**ITEM 4. DEVELOPMENT APPLICATION: 19 CARILLON AVENUE
CAMPERDOWN****FILE NO: D/2013/1973****DEVELOPMENT APPLICATION NO: D/2013/1973****SUMMARY****Date of Submission:** 18 December 2013. Amended plans received on 17 September 2014.**Applicant:** St Andrew's College**Architect:** TKD Architects**Developer:** St Andrew's College**Owner:** The Council of St Andrew's College**Cost of Works:** \$97,845,000**Proposal Summary:** Consent is sought for a Stage 1 campus masterplan proposal, including site layout and building envelopes for new and existing buildings, to create up to 600 student and resident fellow rooms, a total of 159 car parking spaces, demolition, tree removal, landscaping and other site works. Works are proposed to be completed in stages over a period of 5 to 10 years. Stage 2 development applications will be submitted for the detailed design of the buildings.

Figure 26: Amended Health Service Facility viewed from Missenden Road

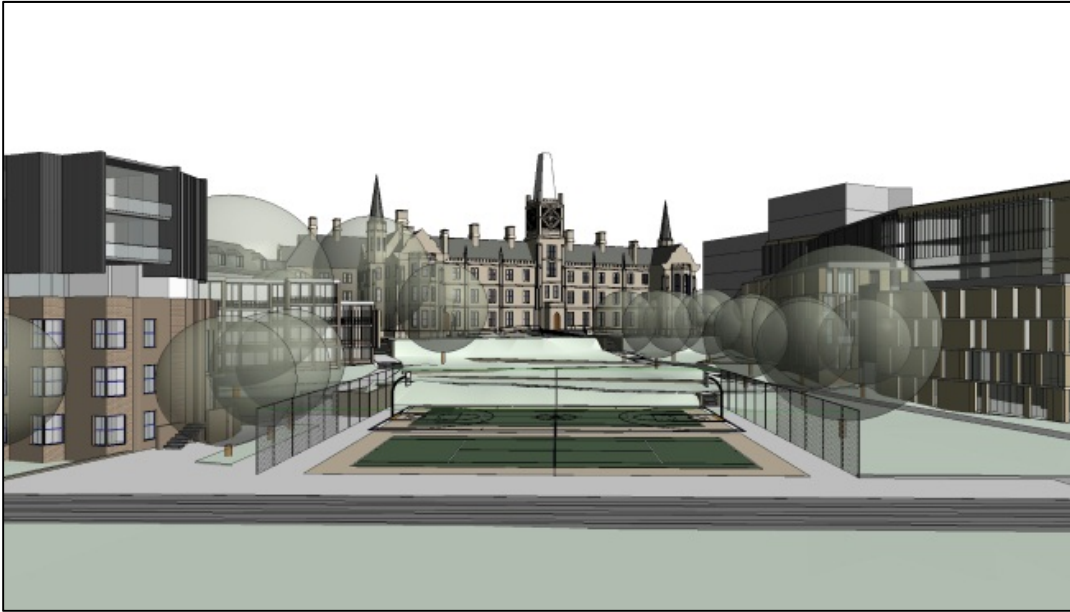
59. However concerns still remain regarding increasing the height of envelope to accommodate the plant level will increase the visual impact on this significant building. Council's Heritage Specialist and Urban Designer recommended that the top most level and any plant on it be shifted further east to the section that is marked as being RL 50.90, which will lessen the visual impact on both the Main building and the grounds of the College.

60. The figures below show that the plant level is not visible from Missenden Road, and when viewed from the College ground looking north and west, the plant level will be viewed against the backdrop of existing taller buildings within the RPAH campus and the Chris O'Brien Lifehouse building.

61. The bulk and scale of the amended proposal is considered to be generally acceptable in the context of the streetscape and adjoining heritage buildings, and is supported, subject to appropriate conditions. In this regard, a condition has been recommended requiring buildings the subject of Stage 2 Development Applications shall be wholly contained within the approved building envelopes. Further, the Stage 2 Development Application for the North building will be subject to a competitive design process, pursuant to Clause 6.21(5) as the proposed building envelope exceeds 25m in height.
